Informal document No. GRPE-61-19
(61st GRPE, 10 – 14 January 2011,
agenda item 6(c))

**Proposal for revision of the document ECE/TRANS/WP.29/GRPE/2011/6
(Revision to ECE/TRANS/WP.29/GRPE/2011/6)**

Regulation No. 83**(Emissions of M₁ and N₁ categories of vehicles)****Proposal for Supplement 2 to the 06 series of amendments to Regulation No. 83****Submitted by the expert from the Netherlands ***

Annex 4, paragraph 6.1.3., amend to read:

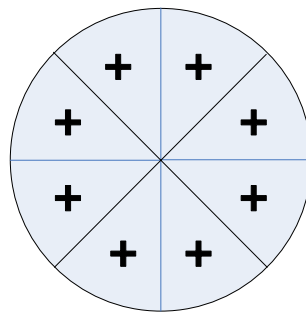
- (a) For blowers with rectangular outlets are located at the centre of each rectangle dividing the whole of the blower outlet into 9 areas (dividing both horizontal and vertical sides of the blower outlet into 3 equal parts). **The centre area shall not be measured (as shown in the diagram below).**

Annex 4a, paragraph 3.4.2., amend to read:

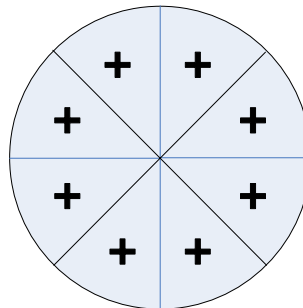
- (a) For blowers with rectangular outlets are located at the centre of each rectangle dividing the whole of the blower outlet into 9 areas (dividing both horizontal and vertical sides of the blower outlet into 3 equal parts). **The centre area shall not be measured (as shown in the diagram below).**
